3000 Series TS-1 Firmware v3.6

Product.....TS-1 Firmware for 3000 and 3000E Traffic Controllers
VersionVersion 3.6
Release Date 11/23/04

Figure 4 – Comm Port 2 Setup screen

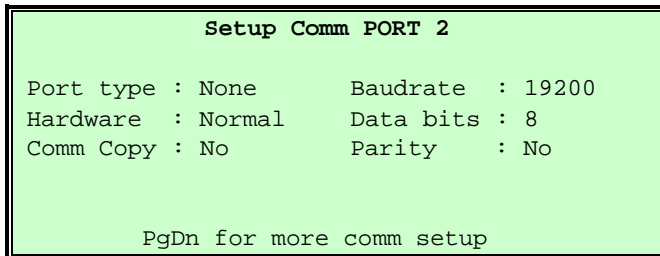
The Comm Port Setup screens have been reorganized so the parameters are easier to understand and use. Previously, when one entered the Comm Setup Screens from the Communications & System Setup menu (MM > 3 > 5 > 2), the controller presented four setup screens (accessible by paging down.) The first of these was a screen where the Master Port, Monitor Port, and Central Port were assigned. This screen has been removed. Now, the controller goes straight to the Comm Port 2 Setup screen:

Whenever Port 2 on the front of the 3000 Series controller is accessed, these settings are used. Use the arrow keys to navigate, and the Y/N key to change the value for a parameter.

Port type – This setting is only used by the controller when it is set to 'Monitor', indicating that an intersection monitor is connected via this port. Note that this setting also allows a monitor to be connected via a modem (if anyone would want to do so.)

Baudrate – Sets the data transfer speed for this port. The firmware will accept values of : 1200, 2400, 4800, 9600, 14400, 19200, 38400, 57600, and 115200 baud. (But the selected rate can only be achieved if the device attached to this port can also communicate at this speed.) This parameter is not displayed if Hardware is set to Ethernet.

Comm Copy – This setting replaces the parameter in the Closed Loop Master/ID screen called 'Allow Comm Transfer Between Ports 2&3'. What this command does is tell the controller to echo the input on this port to the other port. (This works for data input to either port.) Although this setting appears on both the Port 2 and Port 3 screens, there is only a single value for this parameter in the database. So setting this value to Y or N on one port automatically sets it to the same value on the other port.

Hardware – This tells the controller what type of hardware is attached to this port: It can be set to either an ‘AT Modem’ (i.e. a ‘Hayes compatible’ modem), ‘Normal’ or ‘Ethernet’. (Port 2 does not have the ‘Ethernet’ option.)

Figure 5 – Comm Port 3 Setup screen with Hardware set to “Ethernet”

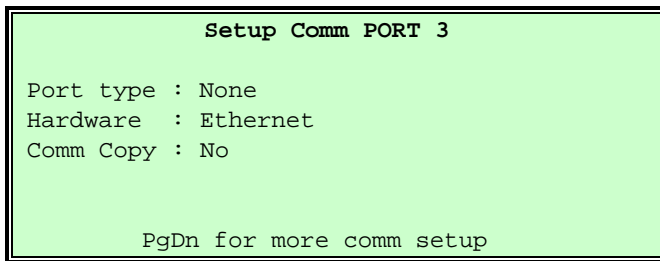
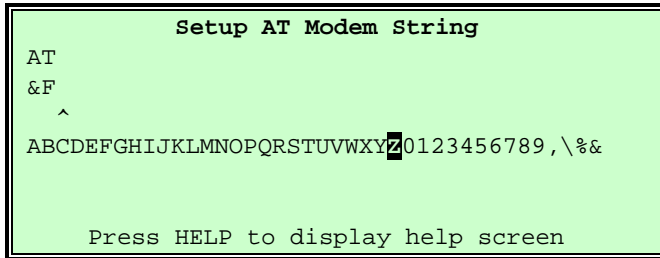
The Setup Comm Port 3 screen is identical to the Port 2 screen, except that there is an additional Hardware setting: Ethernet. If Hardware is set to Ethernet, the right column parameters are hidden. (Ethernet forces these values to their fixed Ethernet values: 115200, 8, No.)

Paging down yet again will take you to the screen where the modem’s ‘AT’ setup string is entered. In firmware v3.6, this screen has been modified to make it easier to enter the desired string. (Note that the firmware automatically puts an ‘AT’ at the beginning of this string, so you do not need to enter these letters.)

The caret symbol (^) shows where the next character will be added on the third line. To add a character, move the highlight cursor (within the alphabet listing) to the desired letter, using the left and right arrow keys, and press **ENTER**.

Figure 6 – Power-on Self Test Error Message with 3 database errors detected

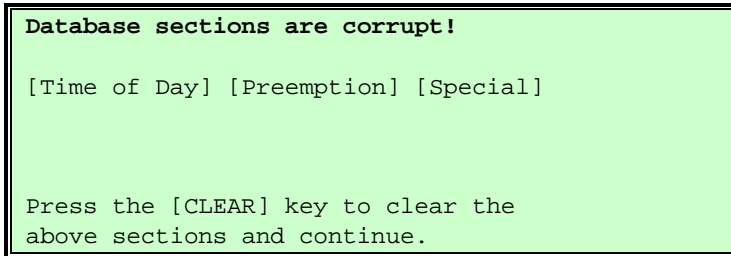
In previous releases of the 3000 series firmware, the configuration databases in the controller were tested every time the system was started using a confusing set of ‘Checksum tests’ and tools in the controller screens that could be used to override they tests if any errors were found. But now, in the version 3.6 release, the firmware simply tests the controller databases upon startup (there are seven of them) and reports immediately if any problems are found. If any problems are discovered, an error screen appears, showing all of the databases where problems were detected. This is what the screen looks like when (for example) three of the databases have errors:

Unlike before, when the controller started up even if it did detect a ‘Checksum’ error, and the operator had to look very carefully at the main dynamic status screen to see if there were problems, the new system uses a CRC test (Cyclic Redundancy Check) and it won’t allow you to start the controller unless you acknowledge that you’ve seen the error by pressing the CLEAR key. This also clears the database contents to a blank state. This is judged to be safer than to allow a corrupted database to be used to run an intersection (as was sometimes done in the past.)

After such an error, the controller’s databases should be reset to default, or good databases should be loaded into the controller via CLMATS, an EPROM card, or by using the Pocket Central software on a Pocket PC handheld device.
